ADDENDUM NO. 3

November 11, 2022

LIBERTY ELEMENTARY SCHOOL RENOVATIONS Chesterton, IN 46304

S-402

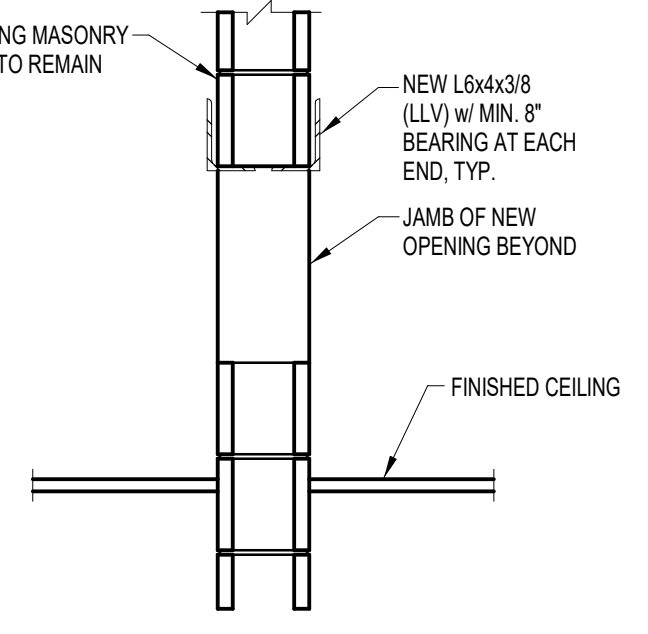
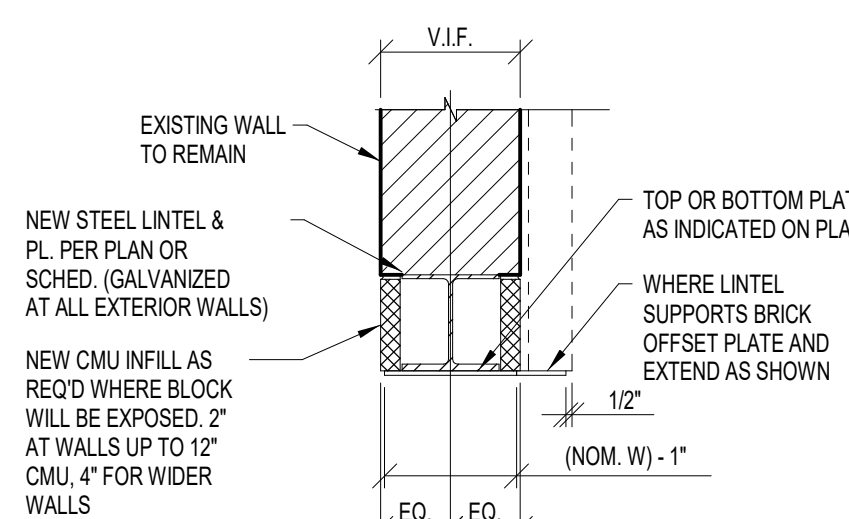
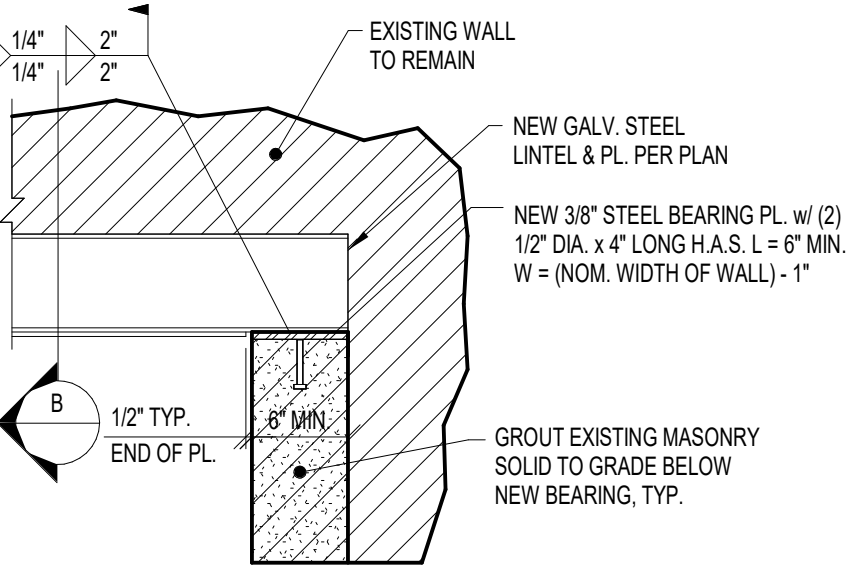
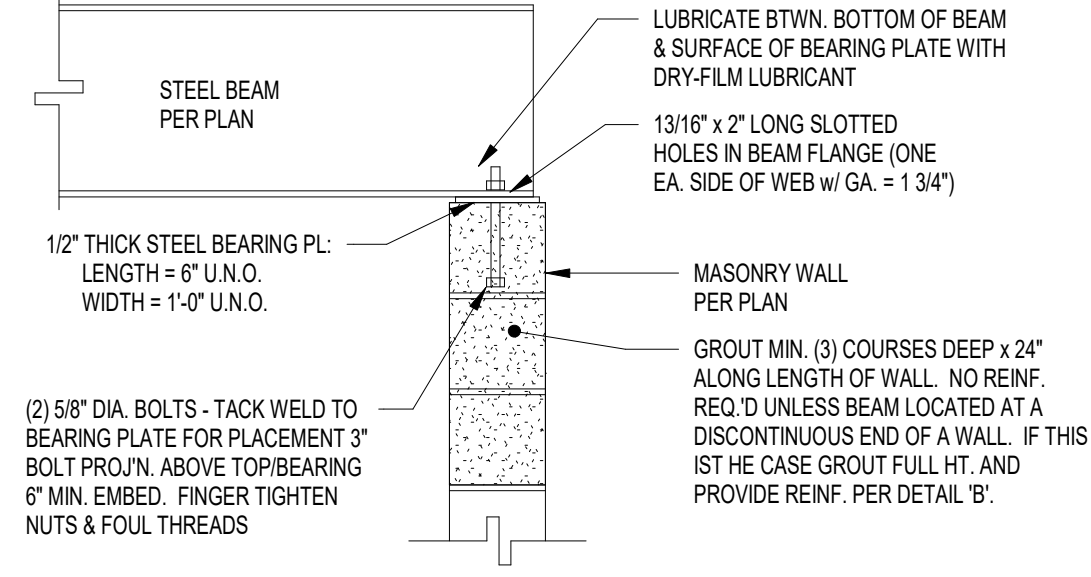
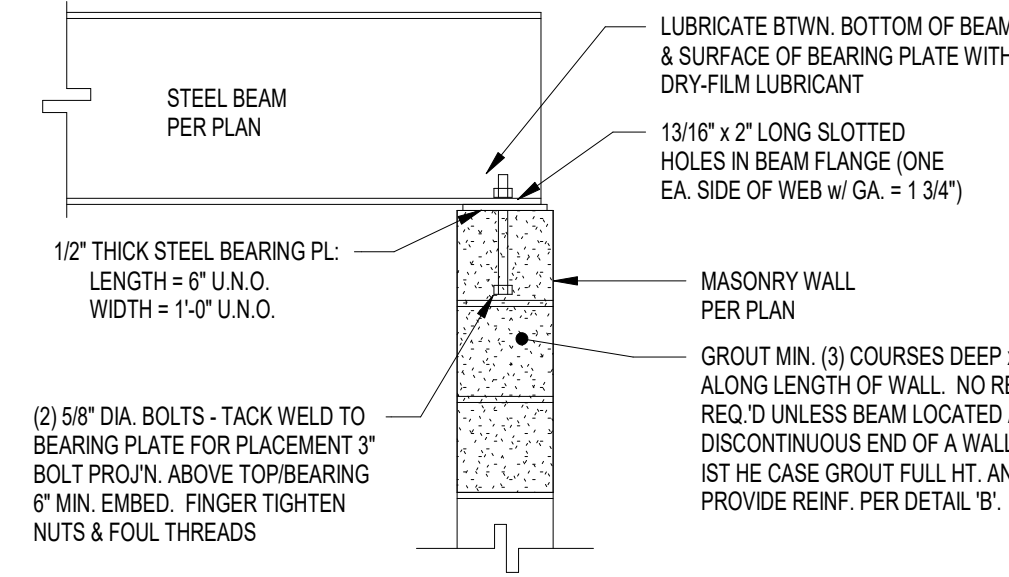
- A. Refer to revised full size drawing, included in this Addendum, for notes added to clarify Detail 10/S-402.

UNIT "A" ARCHITECTURAL FIRST FLOOR DEMOLITION PLAN

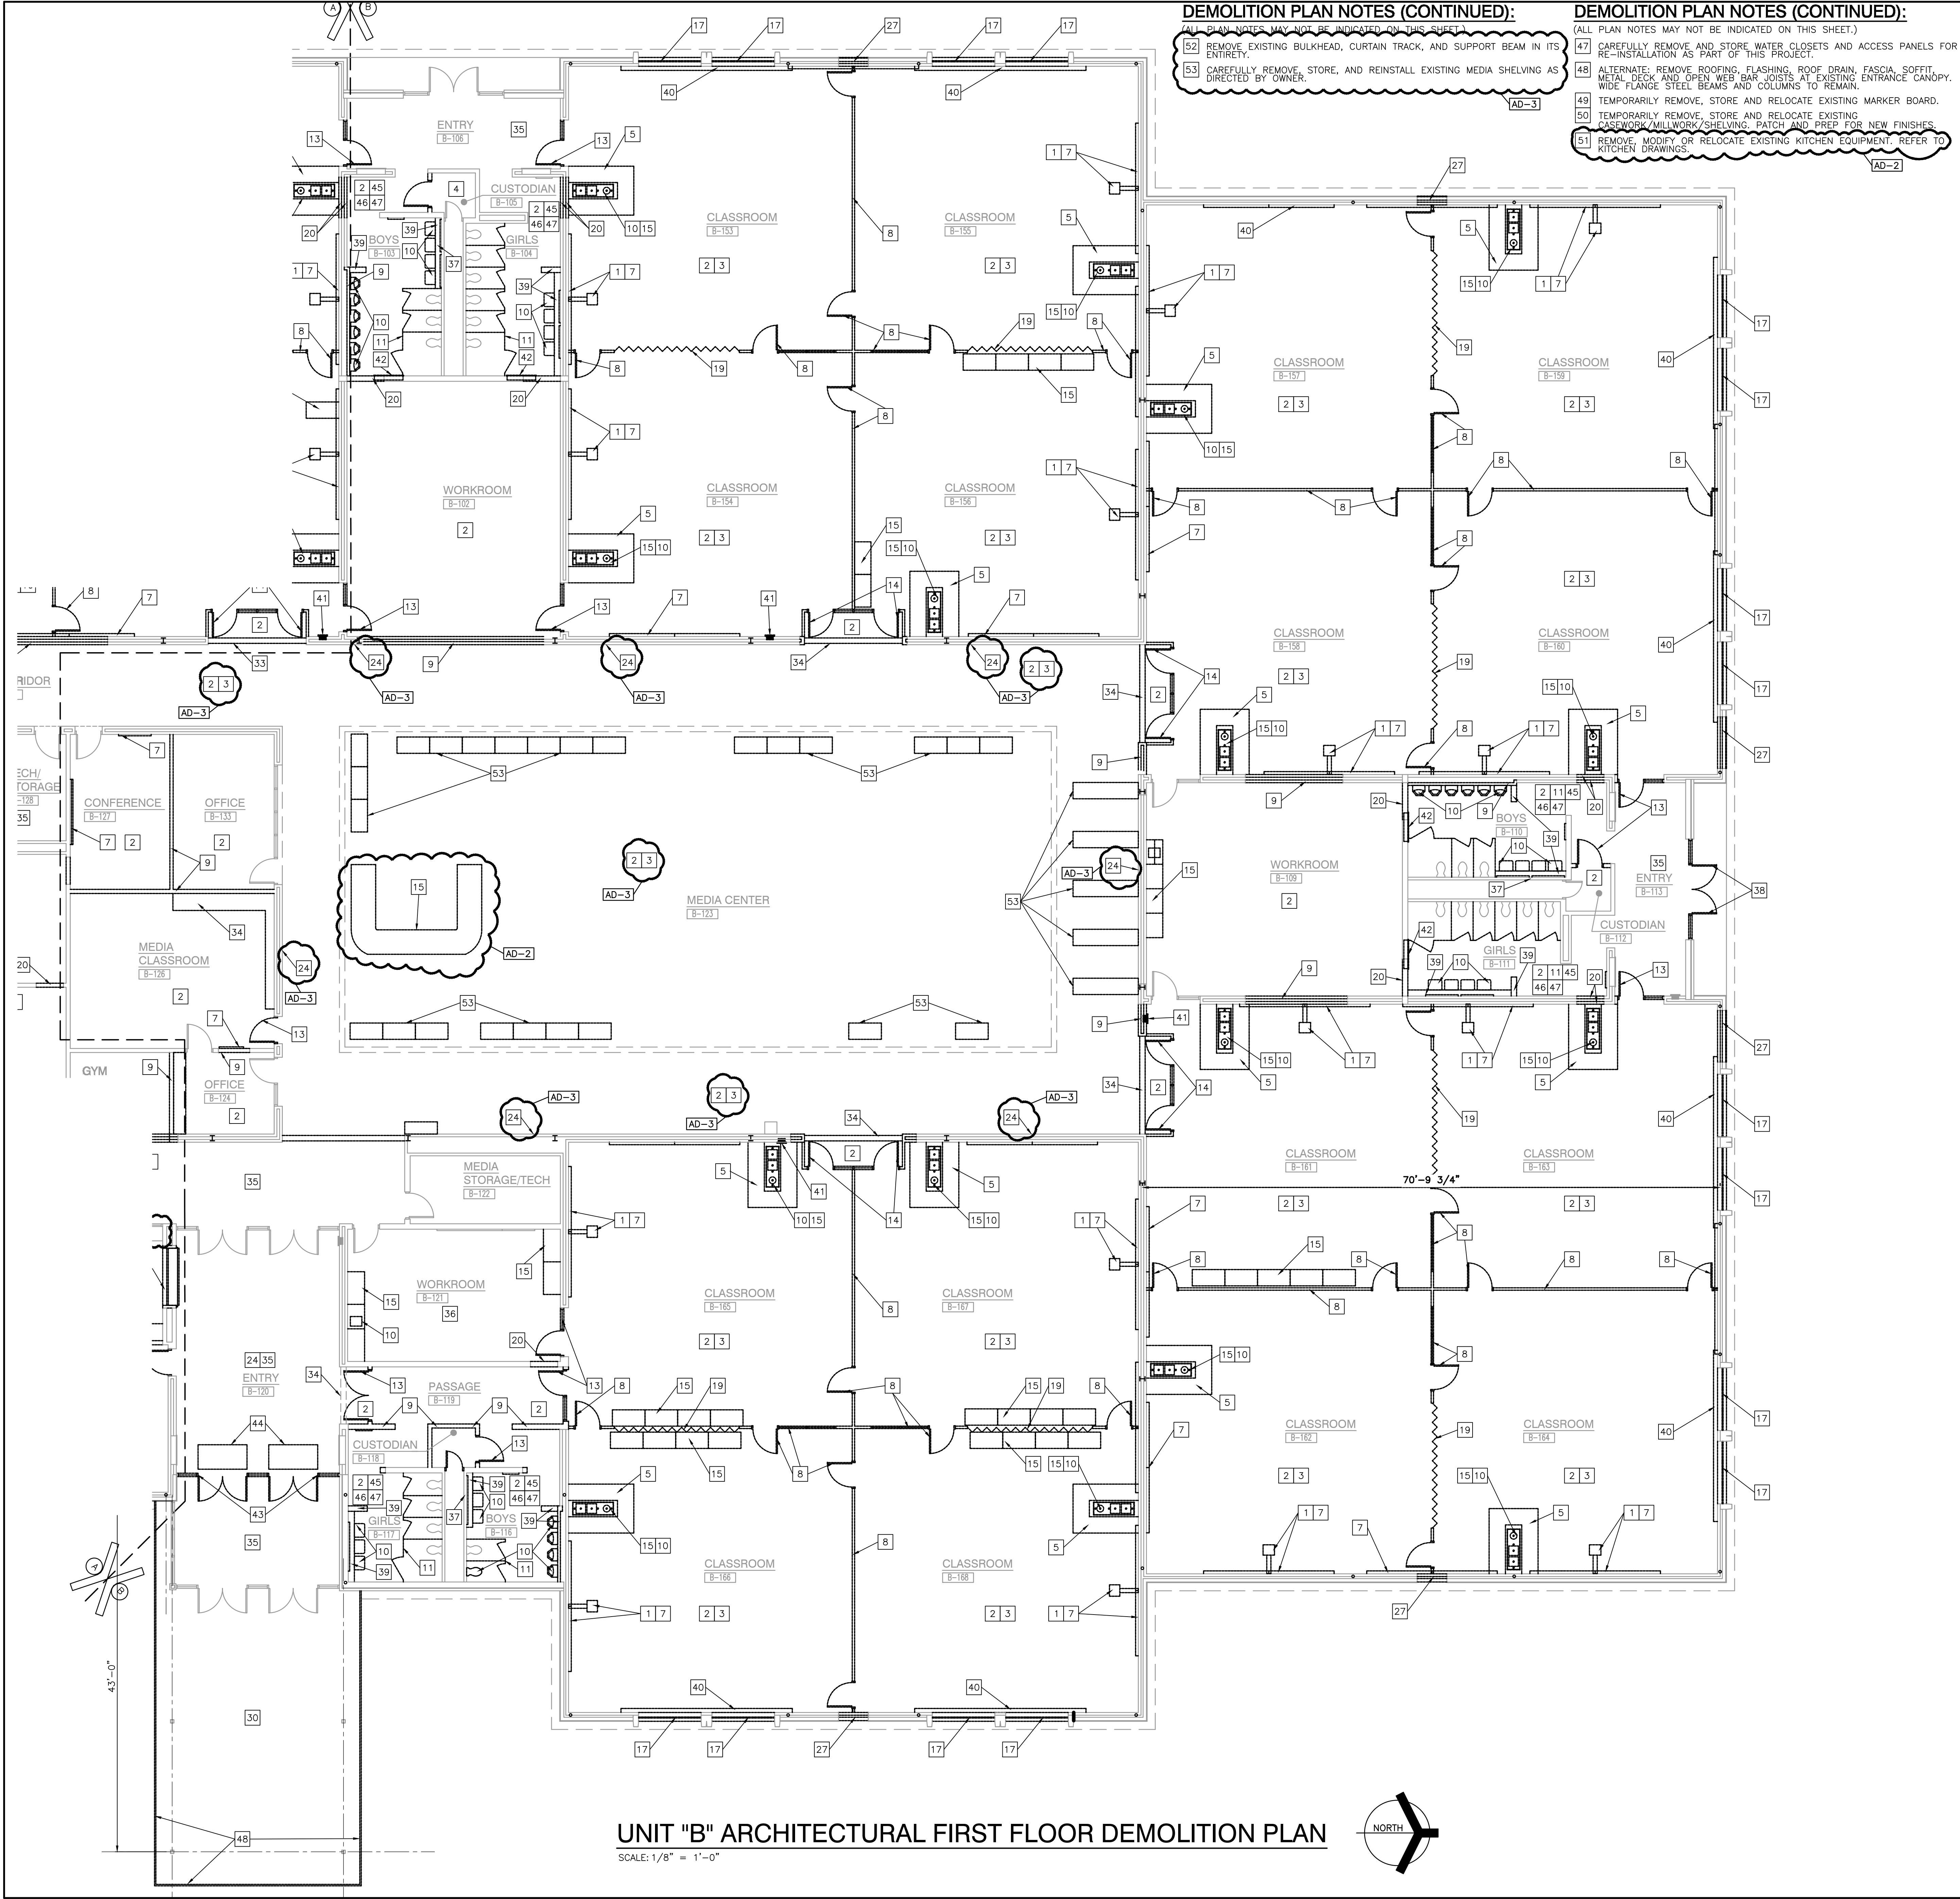
- A. Refer to revised full size drawings, included in this Addendum, for the following revisions:
 - 1. Added and revised Demolition Plan Notes.
 - 2. Added demolition at bulkhead between Cafeteria A-120 and Serving A-125.
 - 3. Clarification of casework demolition at General Office A-106 and Music, A-116.
 - 4. Demolition of existing finishes at Corridor B-129.

**OVERALL ARCHITECTURAL
ROOF PLAN**

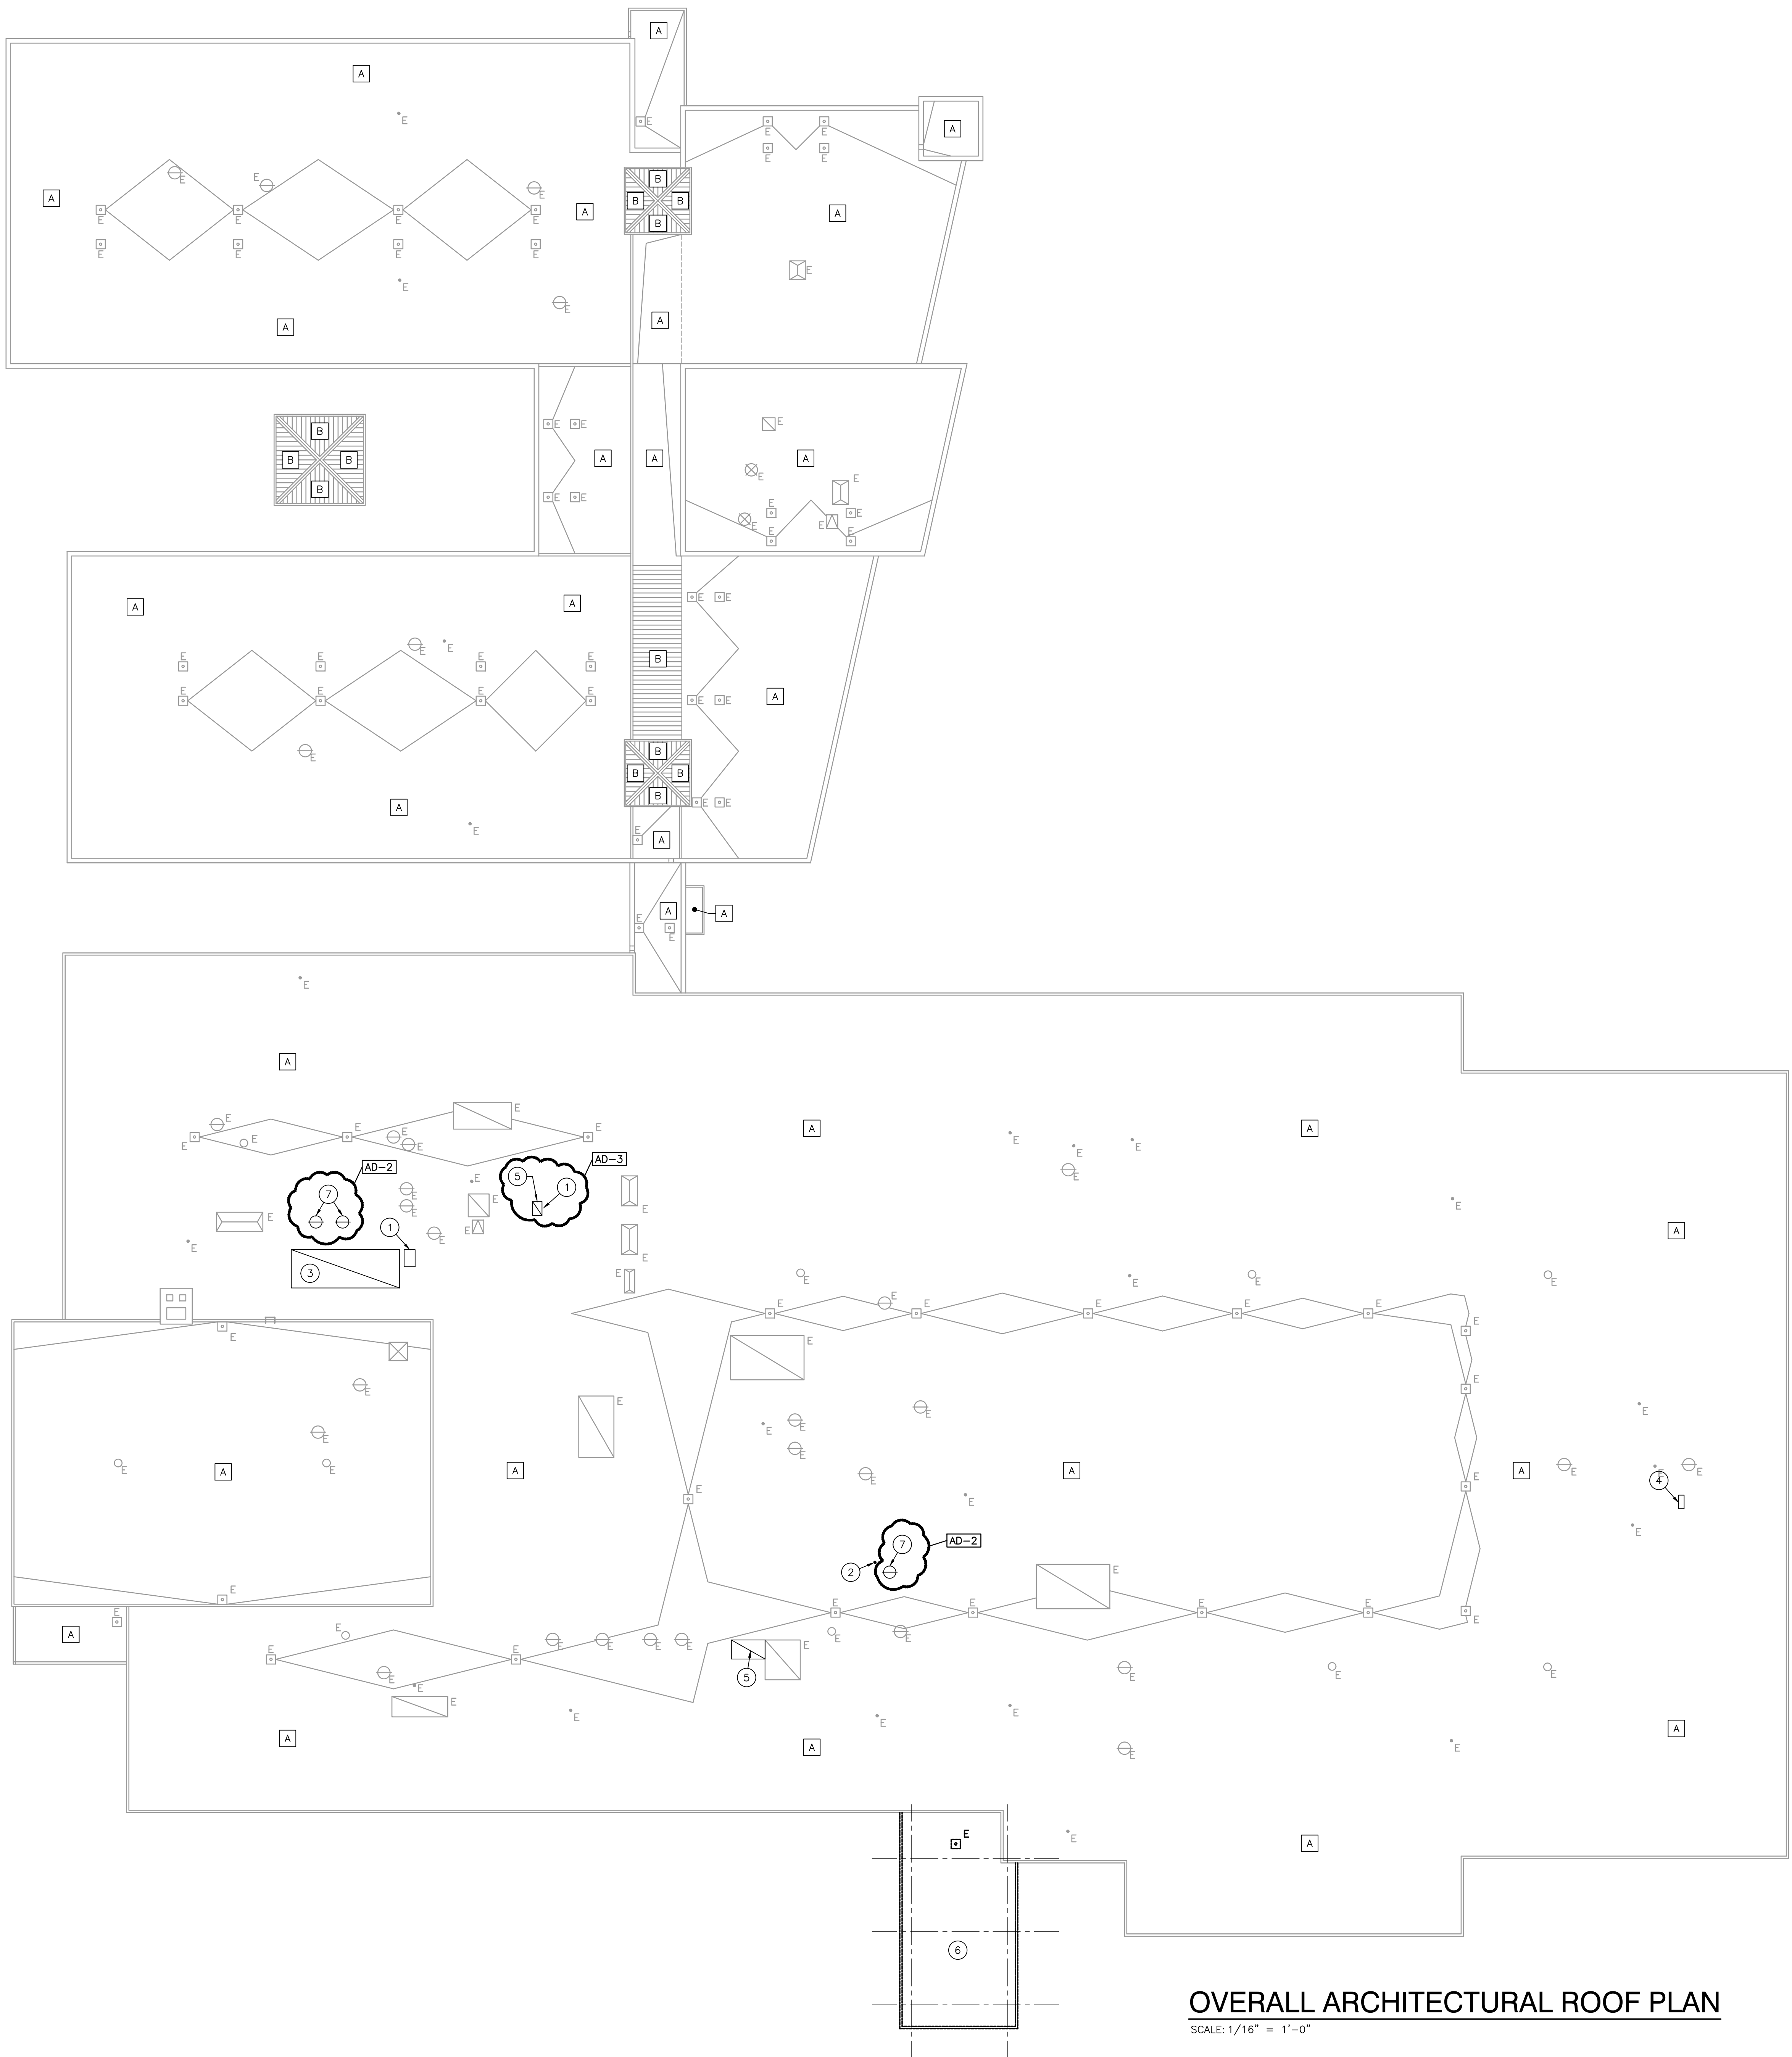
- A. Refer to revised full size drawings, included in this Addendum, for the following revisions:
 - 1. Added new rooftop mechanical equipment and associated notes.
